## REMARKS

This application has been carefully reviewed in light of the Office Action dated January 9, 2003. Claims 1-4 remain pending in this application. Claims 1 and 2 are the independent claims. Favorable reconsideration is respectfully requested.

FIG. 1

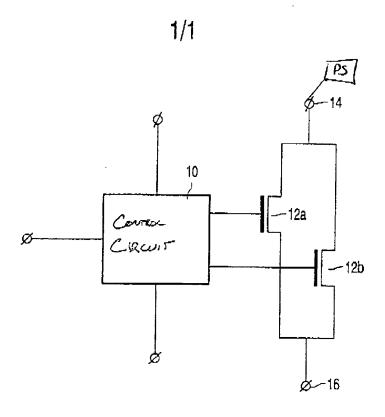
In response to the Office Action's objections to the drawings under 37 CFR 1.83(a), Applicants respectfully request acceptance of substitute Fig. 1 incorporating a power supply source PS attached to a power supply input terminal as proposed in the Office Action. Two (2) copies of substitute Fig. 1 are included herewith. Applicants respectfully believe the amendments to Fig. 1 adequately respond to the objection and render it moot. Applicants request withdrawal of the objection to the specification.
